ADDENDUM NUMBER 1

WALTER ELISHA PARK PHASE II IMPROVEMENTS

TOWN OF FORT MILL

GMC PROJECT NO. LCLT240003

1 TRAFFICGUARD PERMANENT BOLLARD
 3/4" = 1'-0"

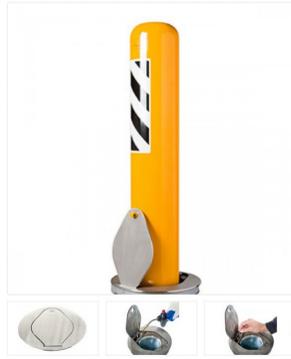
The removable and permanent bollards by Maglin (details L5.02-1 and L5.02-2) have been replaced with different bollards by TrafficGuard. Detail L5.02-7 Bench Swing has been modified to specify square columns matching the existing bench swings on-site. Refer to clouded areas.

Diameter: 6.625" OD
 Bollard Height: 36"
 Wall: .280"
 Mount: Fixed / Embedded
 Finish: POWDER COAT COLOR, BLACK

8 ADA PARKING SIGN
 3/8" = 1'-0"

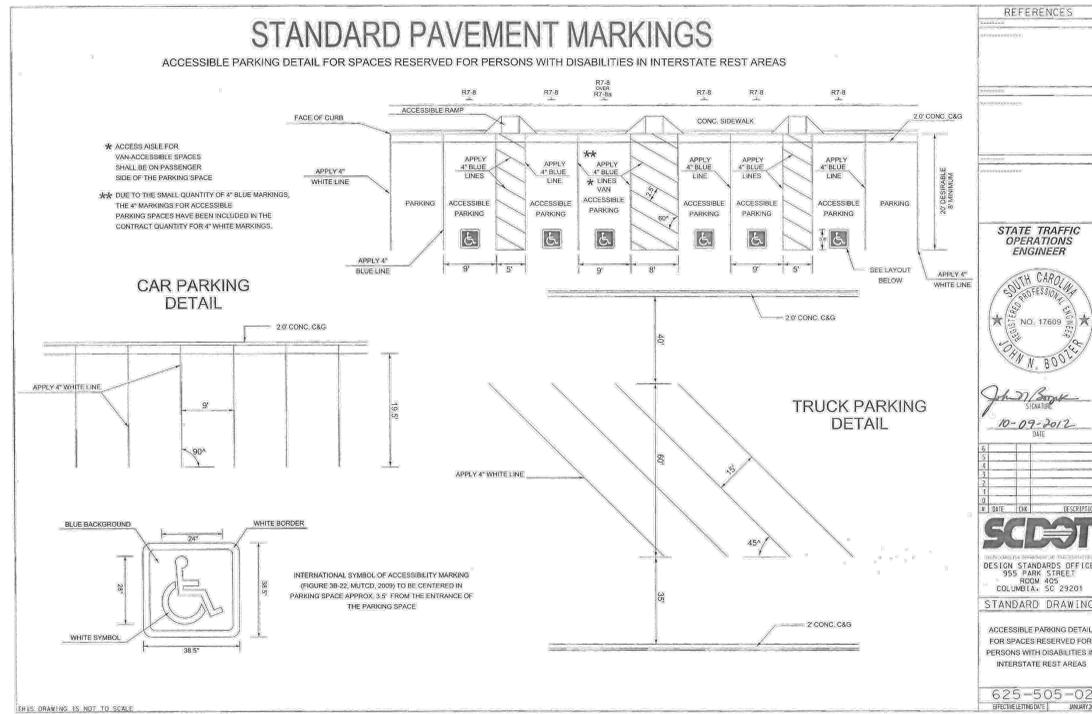
- 4.15 Please provide details on the signs that are to be replaced.

Existing trail signage is to be removed, securely stored, and reinstalled as required for construction. Proposed ADA parking signage is to be installed per detail L5.02-8.
